# Appendix A: Responses to expert's letter dated 22nd November 2024

## Summary of responses

This PDF document shows Beca replies (in blue) to the letter prepared by Mr Lines and Dr Hargraves dated 22nd November 2024. These responses should be read in conjunction with the text in the Statement of Reply of Dan Chamberose (27 November 2024) document under Section 5. SLOPE INSTABILITY SUSCEPTIBILITY OVERLAYS AND DEBRIS RUN-OUT OVERLAY – ACCURACY OF THE OVERLAYS.

Extract from QMAP layer in Beca GIS showing geology and 100 m fault zone (red) below the **Bishopdale Fault**. The other '100 m fault zone' shown far right corner is the **Waimea Fault**. Polygon is the original Bishopdale Subdivision Area.

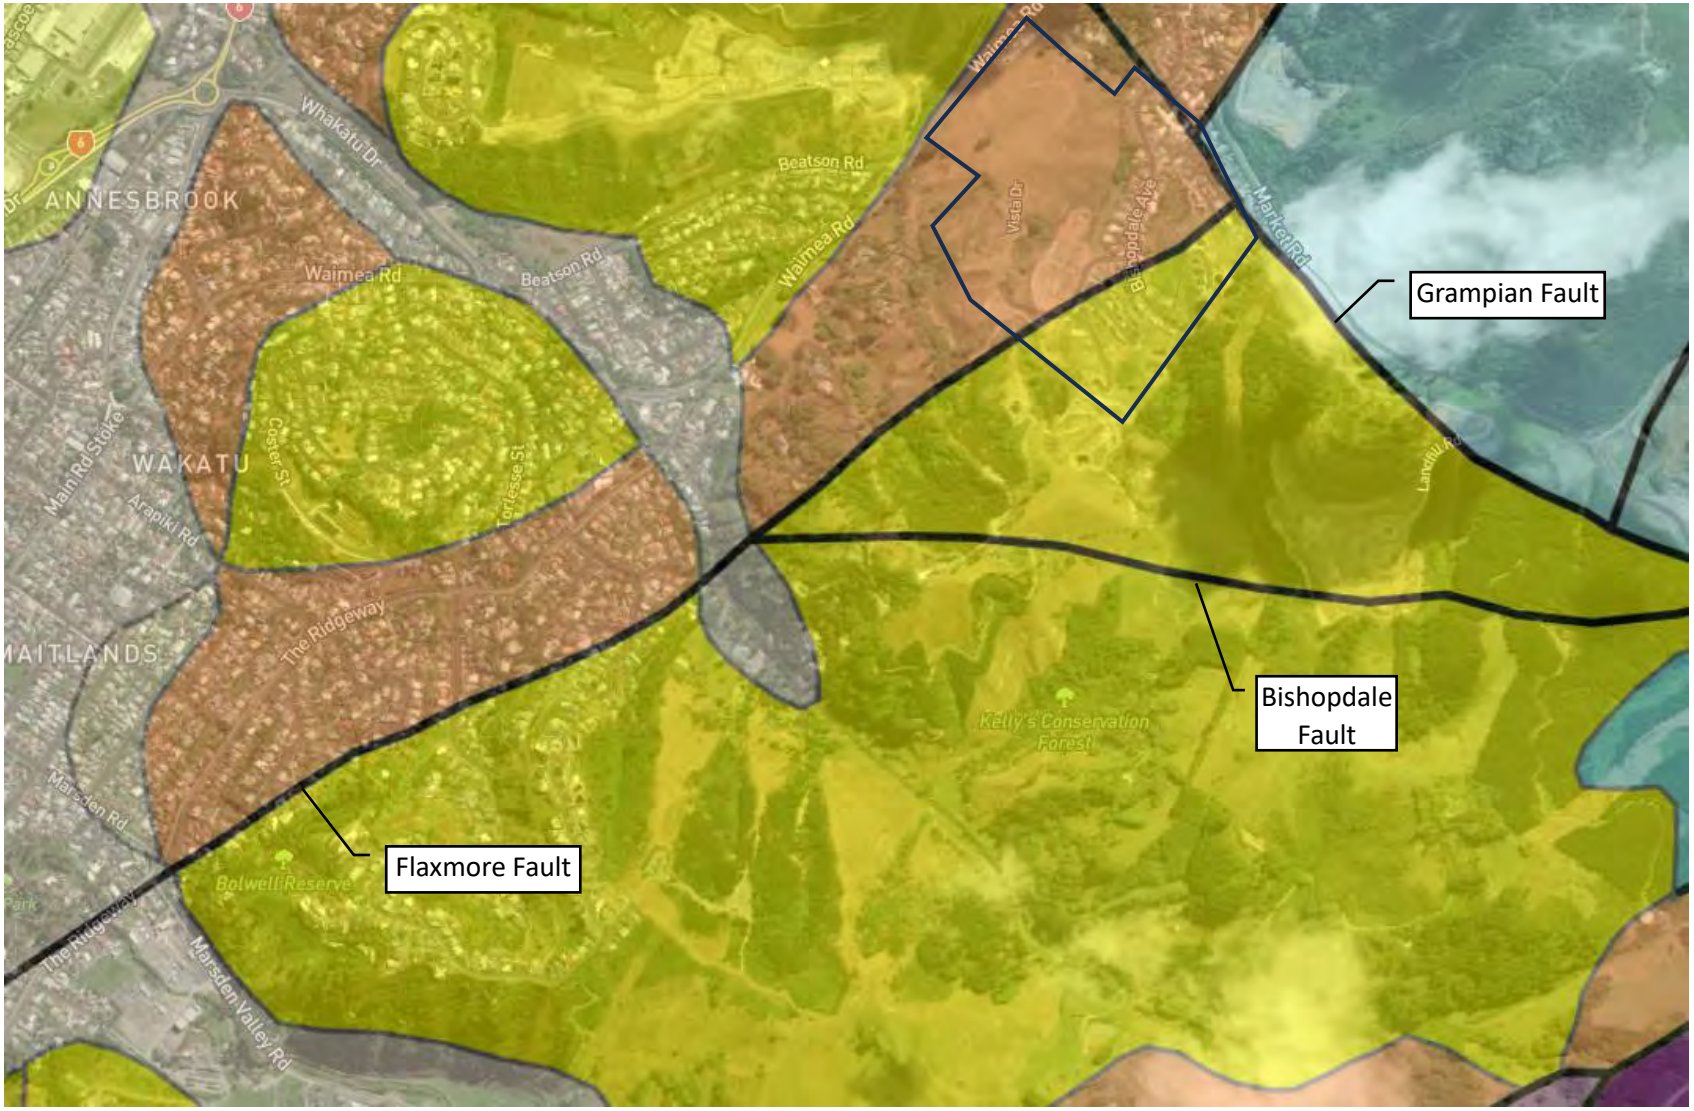
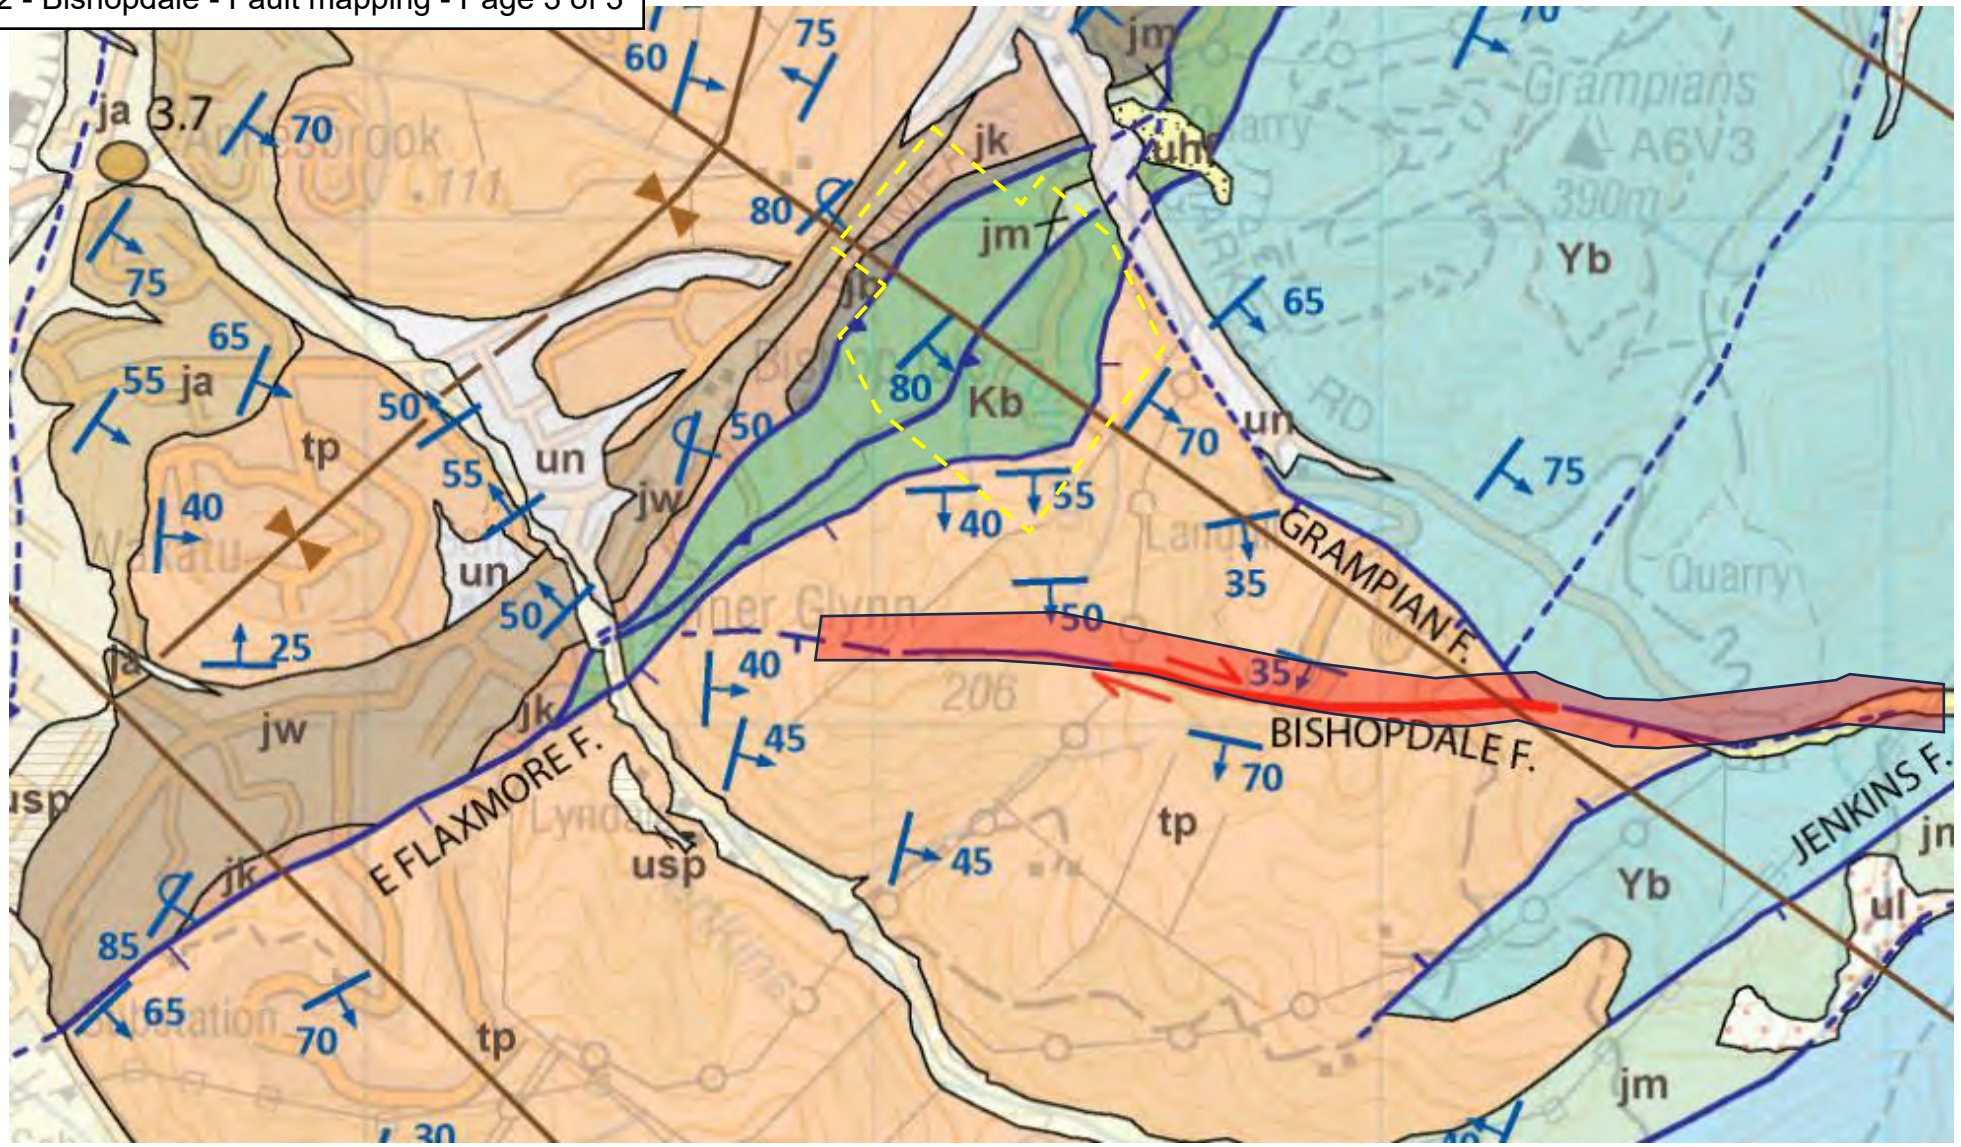
Note how many more faults exist, with three strands of the Flaxmore fault passing through the Bishopdale Subdivision site, none of which have had any offsets included in the Stability mapping. Dark blue lines are faults, with location uncertain if dashed. Thick red lines are 'late Quaternary' fault scarps i.e. active within the Holocene period (11,700 years). The application of the red "100 m offset" is inconsistently (and incorrectly) applied to only some portions of some faults.

The faults included in the 100m downslope of a fault criteria in the methodology tree are the faults presented on the GNS Active Faults database. The AGS guidance identifies that sliding may be possible on steep natural slopes in regions affected by large earthquakes. The 100m downslope of active faults is to reflect this, as well as the consideration that the bedrock near active faults will typically be more fractured and likely to have water seepages. Therefore, these areas are likely to be potentially susceptible to instability.

The updates to the fault deformation/awareness areas postdated the original overlay creation and were therefore not included for consideration as part of these overlays. This criterion of the methodology tree was agreed and accepted by the SI-TAG and no change was suggested.

If these areas were to be incorporated for this plan change, it would result in some new areas of land (beyond those notified in the PC29 overlay) to be included into the overlay. Therefore, for a future plan change, it may be appropriate to develop this criterion of the methodology tree to incorporate the areas downslope of all the active faults identified in the fault deformation/awareness areas.

1943 aerial photo – no signs of deep-seated slip or any other instability in dashed area

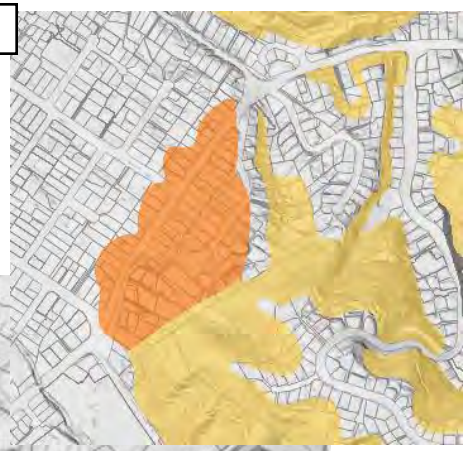
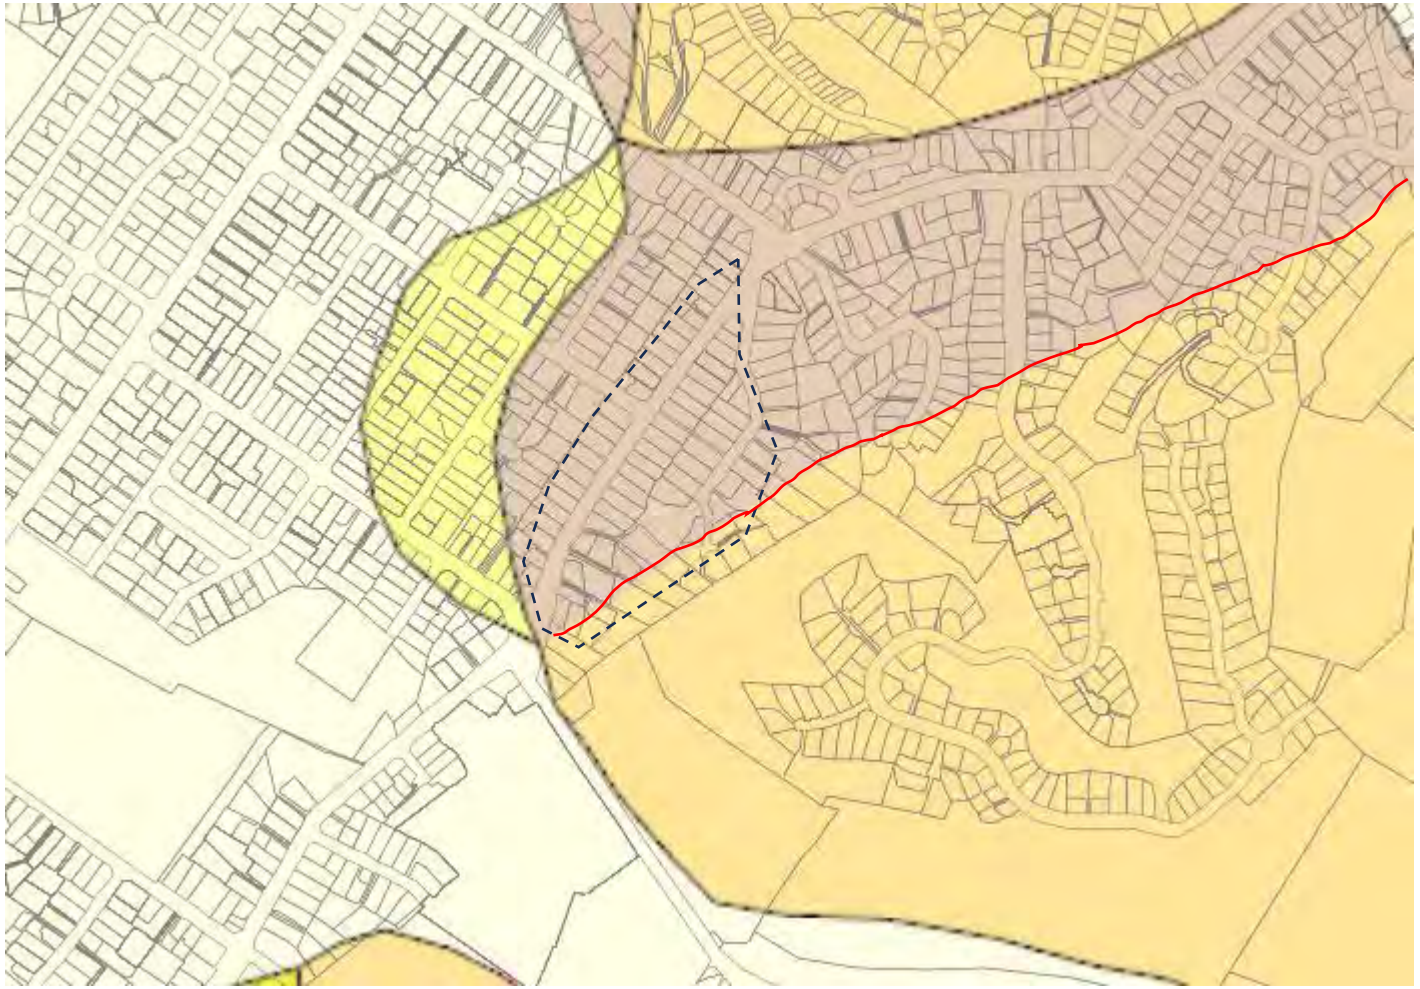
DEM – no signs of deep-seated landslip or other ground movement

QMAP: No reason for Tier 3 for geology purposes & no mapped evidence of deep-seated landslip; no 100 m from fault zone shown.

Addressed as part of A11 + A12

Addressed as part of A11 + A12

A24. Bishopdale - Application of methodology

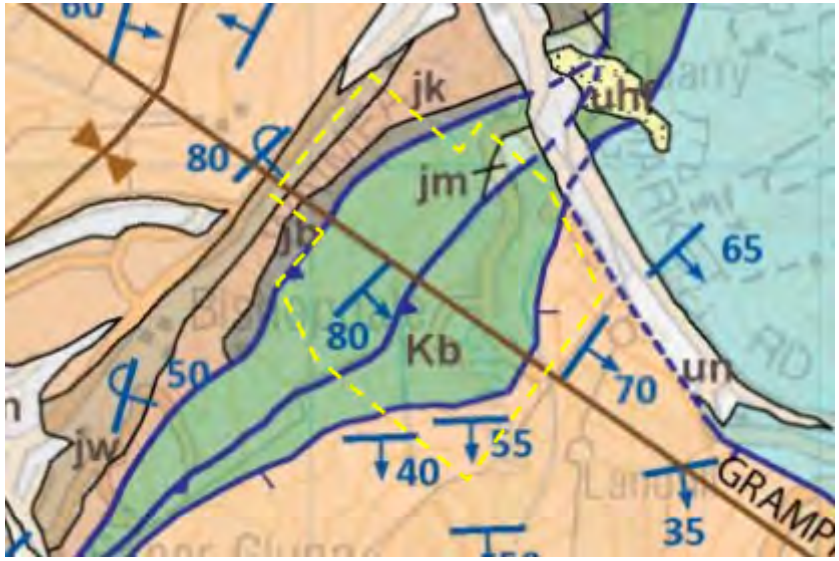
Tier 2 but mapped to be underlain by geology other than Bishopdale Conglomerate or Marsden Coal Measures

Addressed as part of A8
